HC-SB-61-393

Propeller Mounting Nut/Torque Inspection

April 05, 2021

- This revision corrects part number typos for the 107585 mounting nut in Figure 1 and in the "Mounting Nut Torque Inspection" procedure.

107585 Mounting Nut Identification
Figure 1

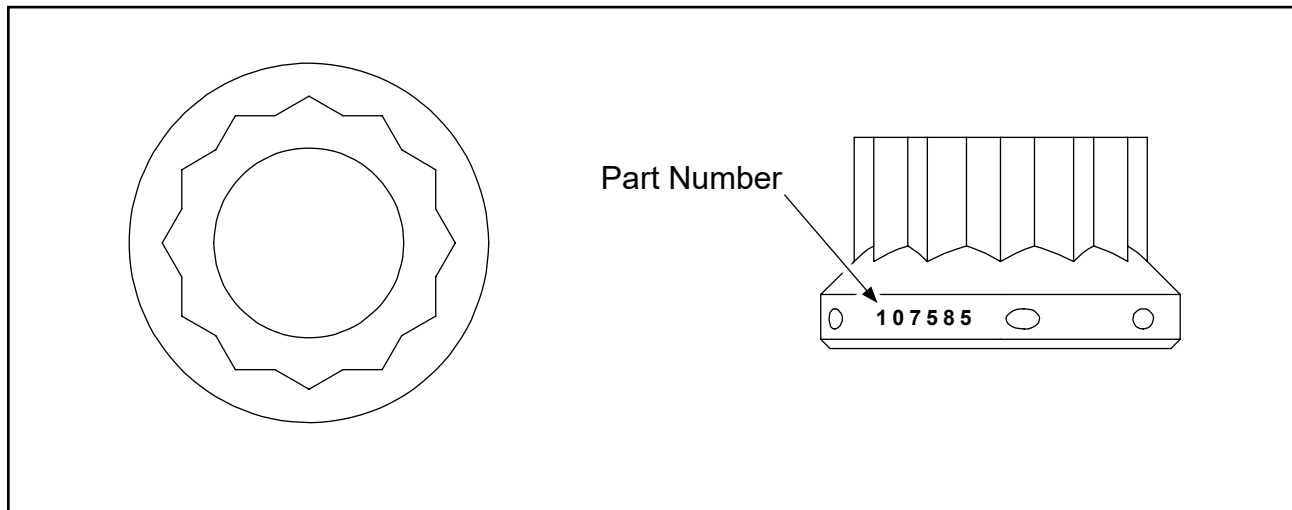
- (a) In Manual 486 (Rev. 2), Table 3-1 ("Propeller Mounting Hardware") listed the propeller mounting nut as p/n C-6006.

- 1 The mounting nut used on the affected propellers is p/n 107585.

NOTE: All of the affected propellers were packaged and shipped from Hartzell with the 107585 mounting nuts. The part number is stamped on the 107585 mounting nuts as shown in Figure 1 of this Service Bulletin.

- (b) In Manual 486 (Rev. 2), Table 3-2 ("Torque Table"), listed the torque for the C-6006 propeller mounting nut as 120-130 Ft-Lbs (163-176 N•m) wet.

- 1 The torque value for the 107585 mounting nut is 100-105 Ft-Lbs (136-142 N•m) wet.

**Beta Feedback Block Assembly
Figure 2**

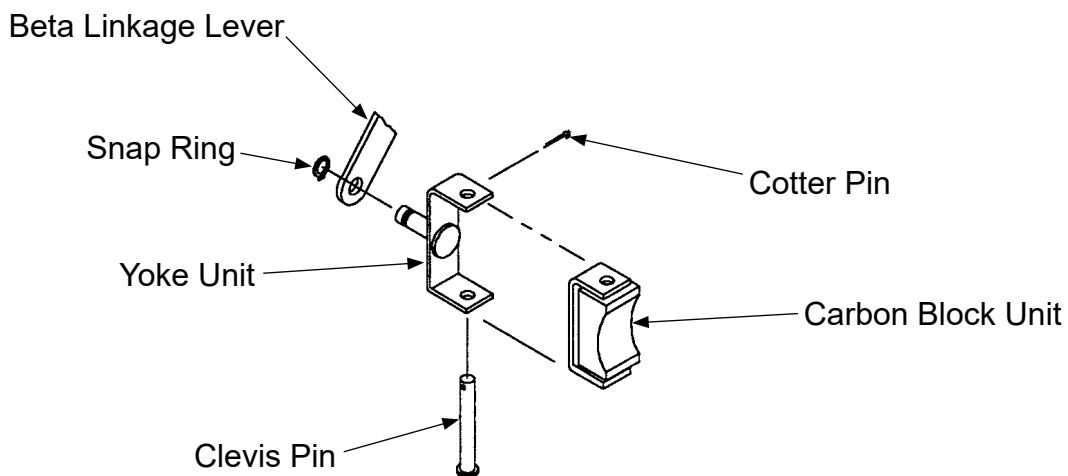
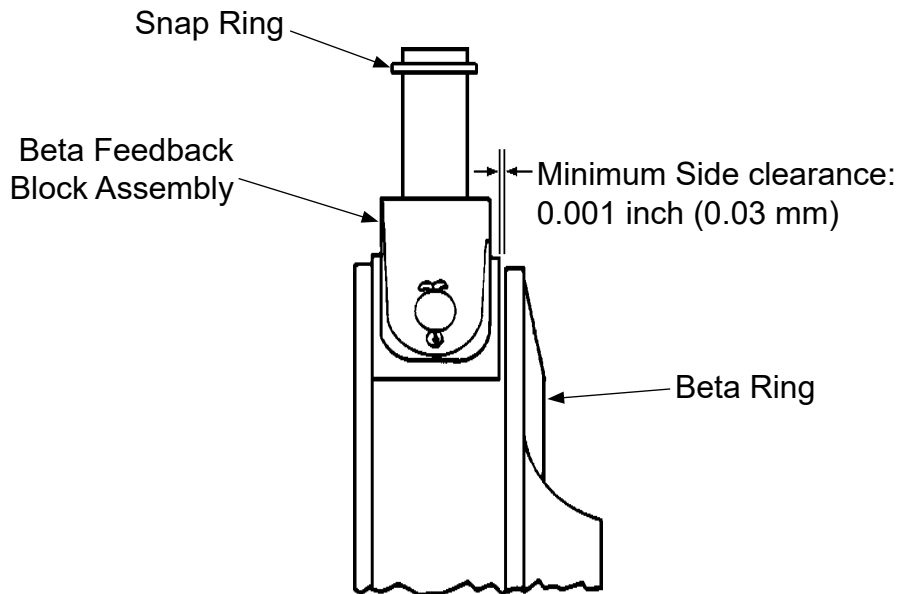
CAUTION: FIT THE BETA FEEDBACK BLOCK ASSEMBLY IN THE BETA RING WITH A MINIMUM SIDE CLEARANCE OF 0.001 INCH (0.03 mm). REFER TO FIGURE 2.

- (9) Install the beta feedback block assembly into the beta ring. Refer to Figure 2.
- (10) Install, adjust, and safety the beta linkage in accordance with the airframe manufacturer's instructions.
- (11) Install the spinner dome in accordance with Hartzell Propeller Inc. Owner's Manual 486 (61-00-86).
- (12) Make an entry in the propeller logbook indicating the "Mounting Nut Torque Inspection" was completed in accordance with this Service Bulletin.

**Torquing Sequence for Propeller Mounting Nuts
Figure 3**

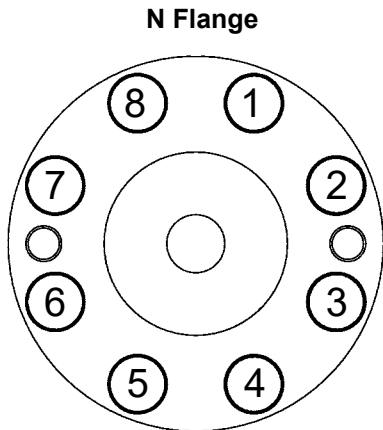
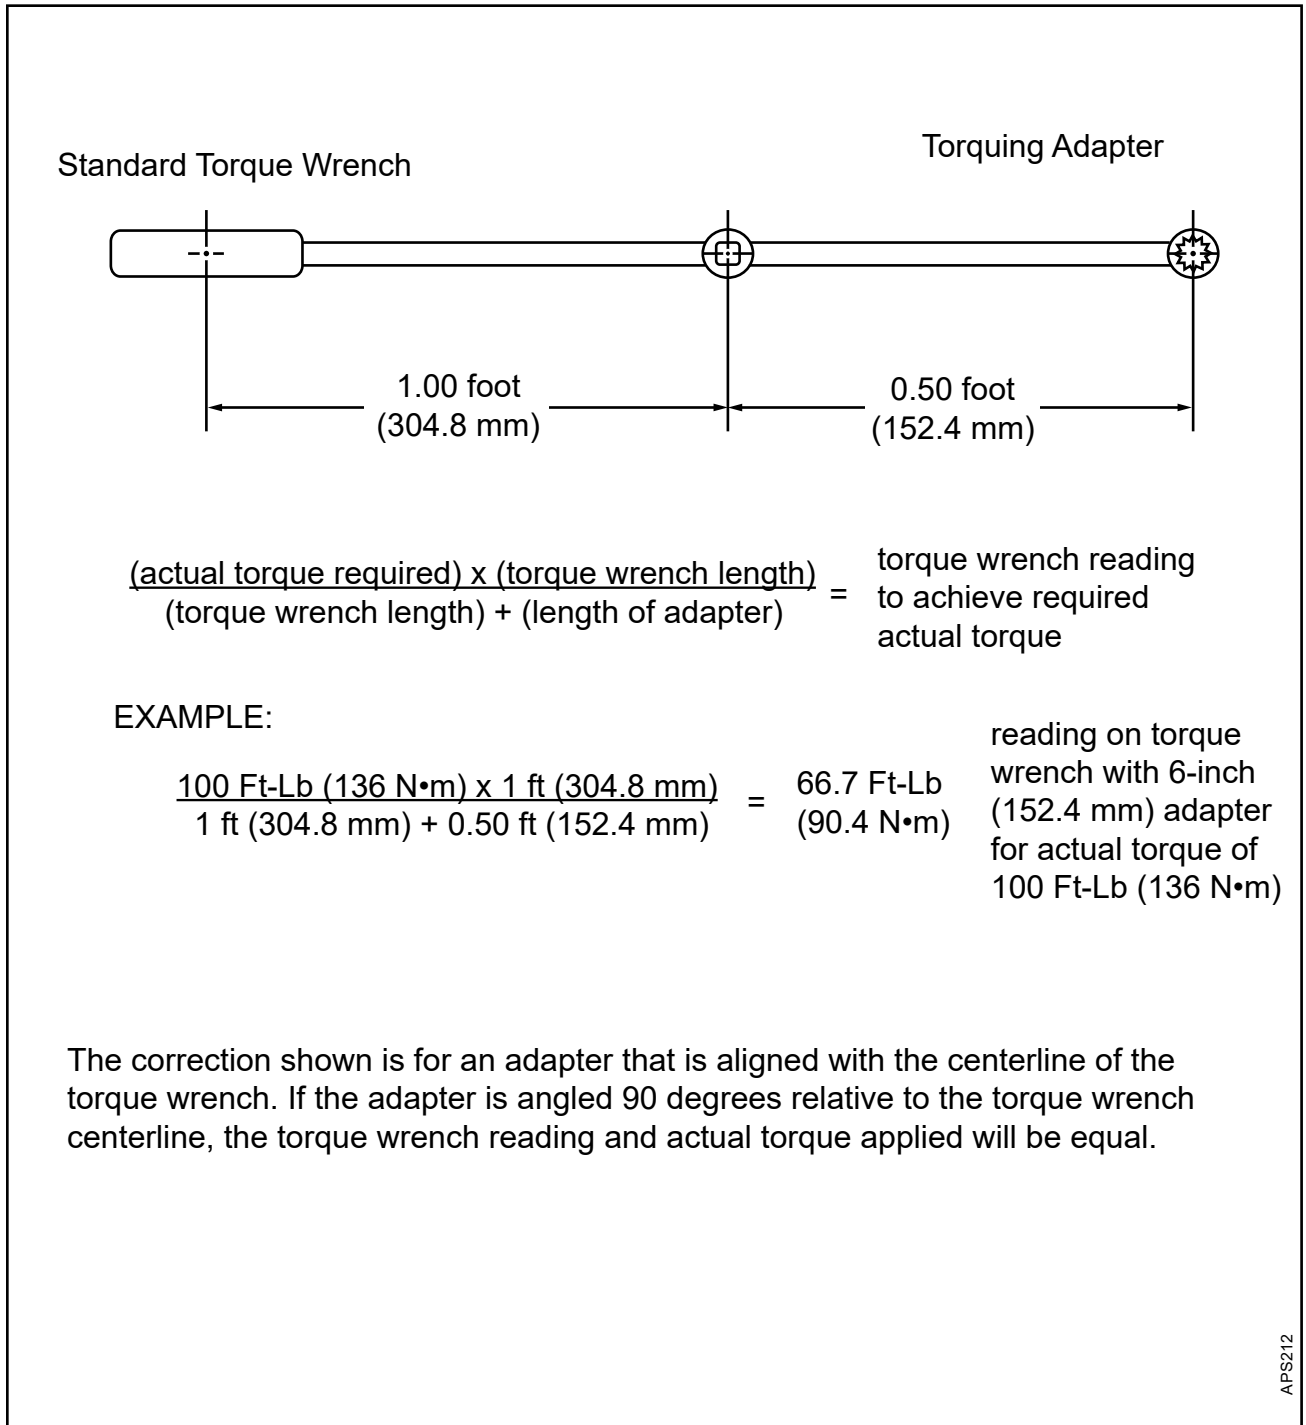
CAUTION 2: REFER TO FIGURE 3 FOR PRELIMINARY TORQUE VALUES AND PROPER TORQUING SEQUENCE FOR THE PROPELLER MOUNTING NUTS.

Step 1: Torque all nuts to 40 Ft-Lbs (54 N•m) Wet

Step 2: Torque all nuts to 80 Ft-Lbs (108 N•m) Wet

Step 3: Torque all nuts to 100-105 Ft-Lbs
(136-142 N•m) Wet
